ST. LUCIE PLANT UNIT NO. 1

AMENDMENT TO FACILITY OPERATING LICENSE

Amendment No. 130
License No. DPR-67

ATTACHMENT TO LICENSE AMENDMENT NO. 130

FIGURE 2.1-1 REACTOR CORE THERMAL MARGIN SAFETY LIMIT -
FOUR REACTOR COOLING PUMPS OPERATING

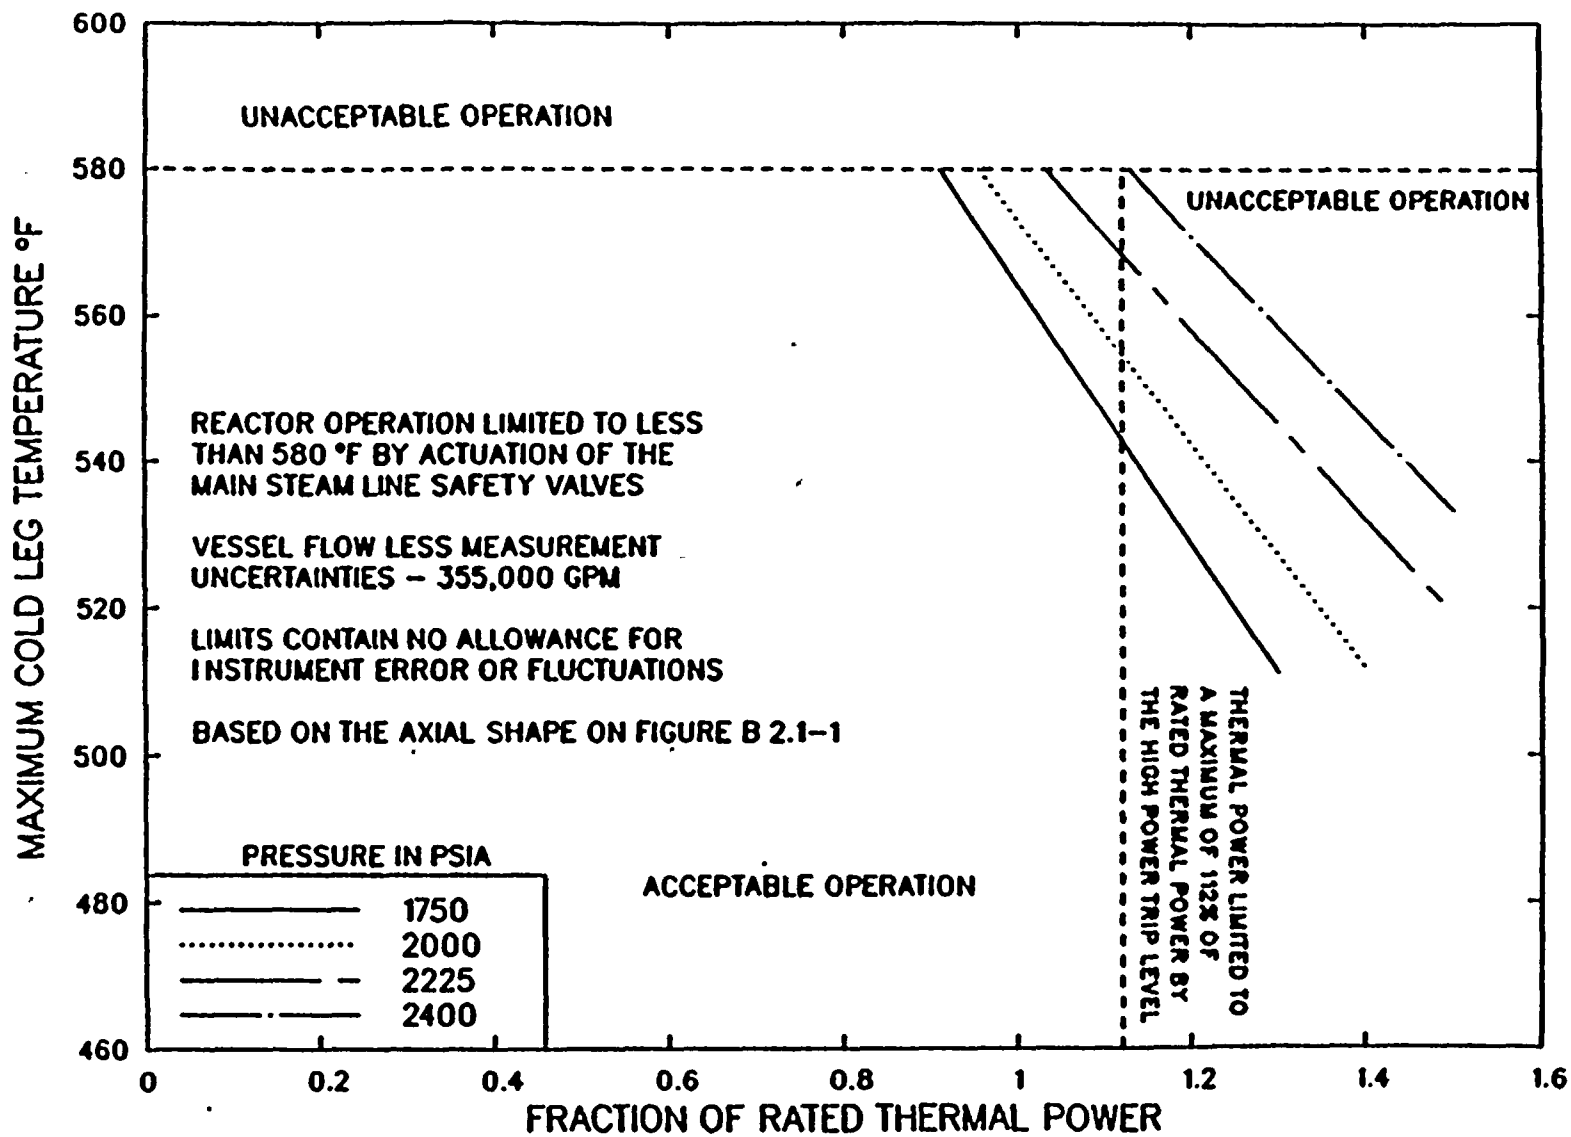
2.1.1 The combination of THERMAL POWER, pressurizer pressure, and maximum cold leg coolant temperature shall not exceed the limits shown on Figure 2.1-1.

Whenever the point defined by the combination of maximum cold leg temperature and THERMAL POWER has exceeded the appropriate pressurizer pressure line, be in HOT STANDBY within 1 hour.

FIGURE B 2.1-1 AXIAL POWER DISTRIBUTION FOR THERMAL MARGIN SAFETY LIMITS

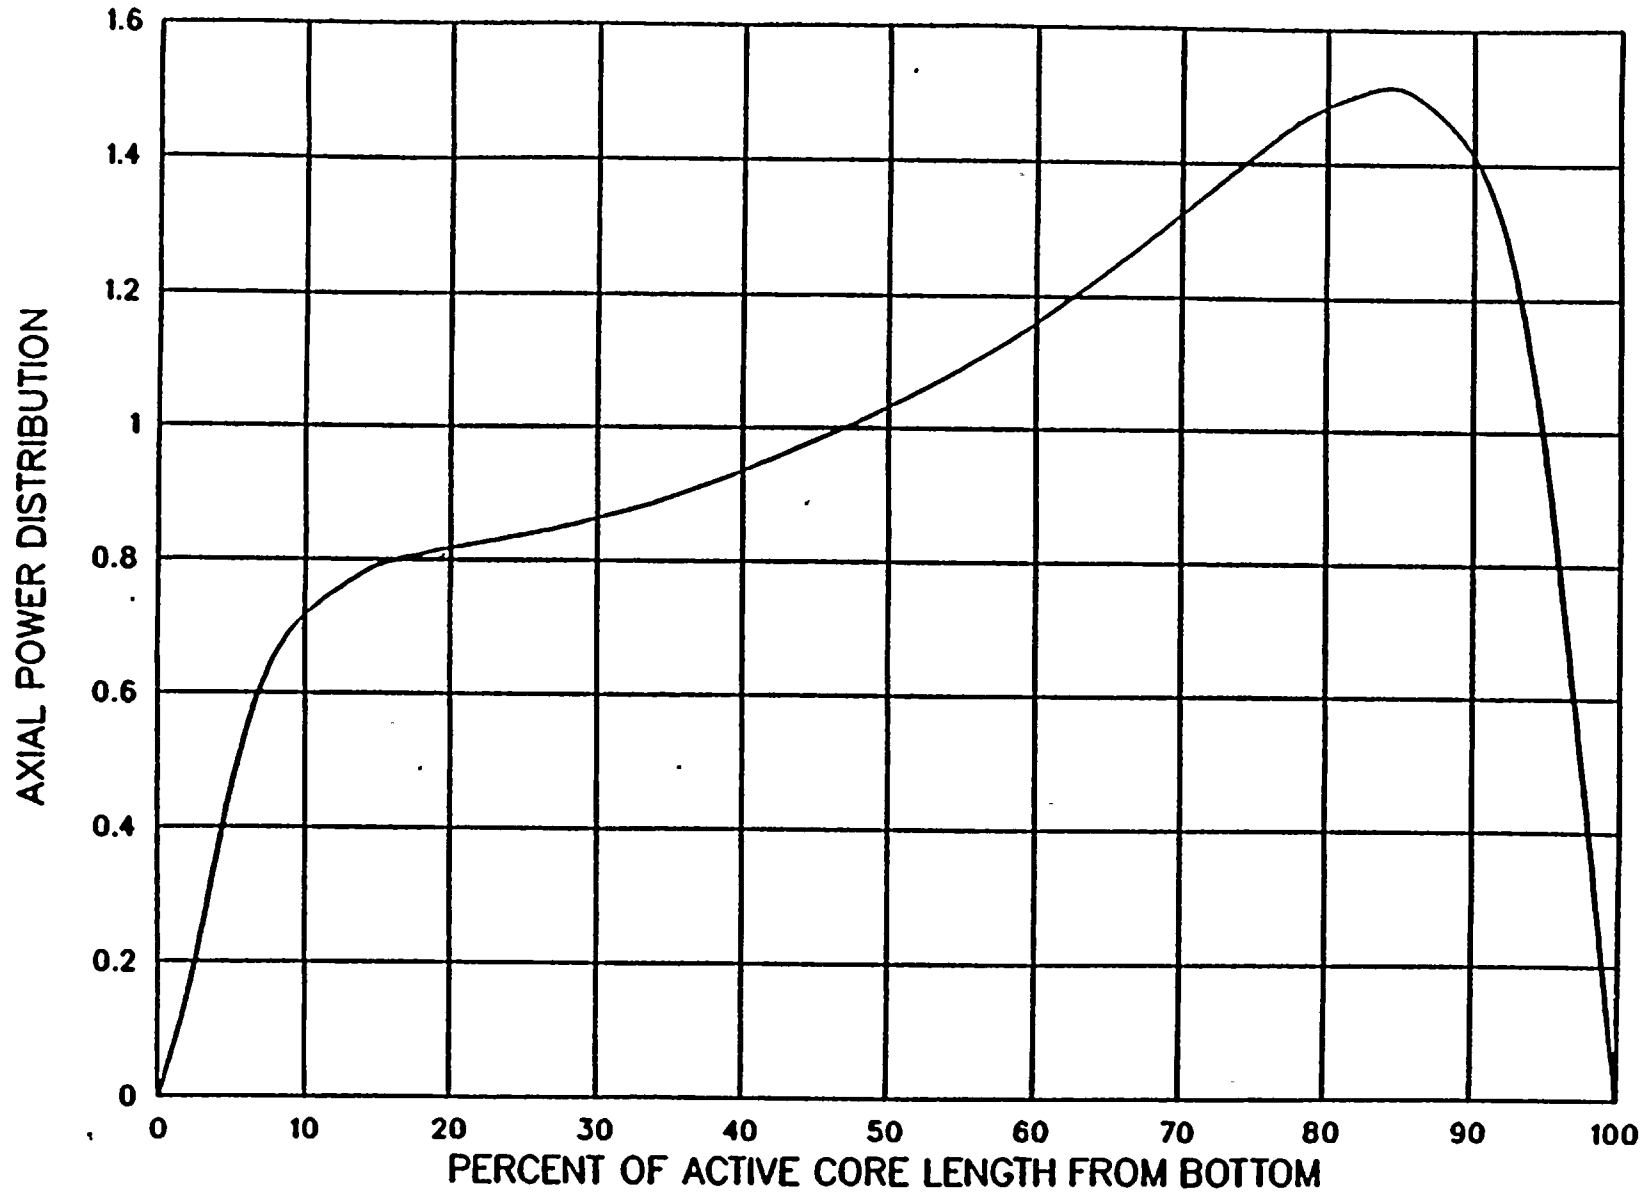
The curves of Figure 2.1-1 show the loci of points of THERMAL POWER, Reactor Coolant System pressure and maximum cold leg temperature with four Reactor Coolant Pumps operating for which the minimum DNBR is no less than the DNBR limit for the axial shape shown in Figure B 2.1-1. The limits in Figure 2.1-1 were calculated for reactor coolant inlet temperatures less than or equal to 580°F. The dashed line at 580°F coolant inlet temperature is not a safety limit; however, operation above 580°F is not possible because of the actuation of the main steam line safety valves which limit the maximum value of reactor inlet temperature. Reactor operation at THERMAL POWER levels higher than 112% of RATED THERMAL POWER is prohibited by the high power level trip setpoint specified in Table 2.1-1. The area of safe operation is below and to the left of these lines.
